GENERAL MOTORS CORPORATION

NVS-212am
PE08-054

This letter is General Motors' (GM) response to your information request (IR), dated 19 Sept 08, regarding allegations of stop lamp malfunction in MY 2005-2007 Pontiac G6 vehicles manufactured by General Motors Corporation (GM).

Figure 13-1 Brake Lamp function with respect to BAS signal voltage

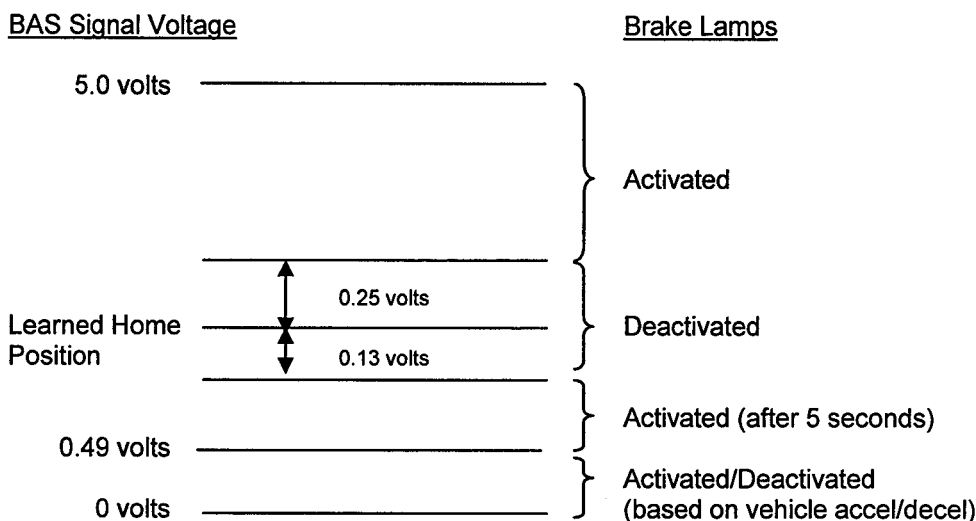
13. Furnish GM's assessment of the alleged defect in the subject vehicle, including:

- a. The causal or contributory factor(s);**
- b. The failure mechanism(s);**
- c. The failure mode(s);**
- d. The risk to motor vehicle safety that it poses;**
- e. What warnings, if any, the operator and the other persons both inside and outside the vehicle would have that the alleged defect was occurring or subject component was malfunctioning; and**
- f. The reports included with this inquiry.**

As described in response to question 12, the Body Control Module (BCM) receives a Brake Apply Sensor (BAS) signal voltage and uses that signal to activate or deactivate the brake lamps. The suspected failure mechanism is fretting corrosion at the terminal interface between the BCM and the instrument panel harness of the BAS circuits. Fretting corrosion causes an increase in resistance that results in a lower BAS signal voltage to the BCM.

As shown in Figure 13-1, when the signal voltage drops into a range that is above 0.49 volts, but below 0.13 volts below the learned home position, the BCM activates the brake lamps after five seconds. They remain activated while the signal voltage is in this range. When the brake pedal is depressed, the brake lamps are deactivated once the signal voltage rises above 0.13 volts below the learned home position. Depressing the brake pedal farther will activate the brake lamps once the signal voltage rises above 0.25 volts past the learned home position. Operators whose vehicles have this condition may notice that the cruise control will not engage and the brake pedal requires additional travel to remove the gear shift mechanism from PARK. Additionally, the transmission converter clutch will not engage.

The BCM control of the brake lamps goes into a different mode if the signal voltage drops below 0.49 volts. This condition indicates an "open circuit" and the BCM sets a diagnostic trouble code. In this mode, the BCM activates the brake lamps once the vehicle is shifted from PARK. The brake lamps will be deactivated anytime the vehicle speed is above 2 kph, is accelerating, and the throttle is engaged at least 20%. In this mode, the transmission converter clutch will not engage and operators may notice that the cruise control will also not engage. While in PARK, with the key in the ACCESSORY or RUN positions and the shifter button depressed, the BCM energizes the Brake Transmission Shift Interlock solenoid so that the shift mechanism can be moved from the PARK position.
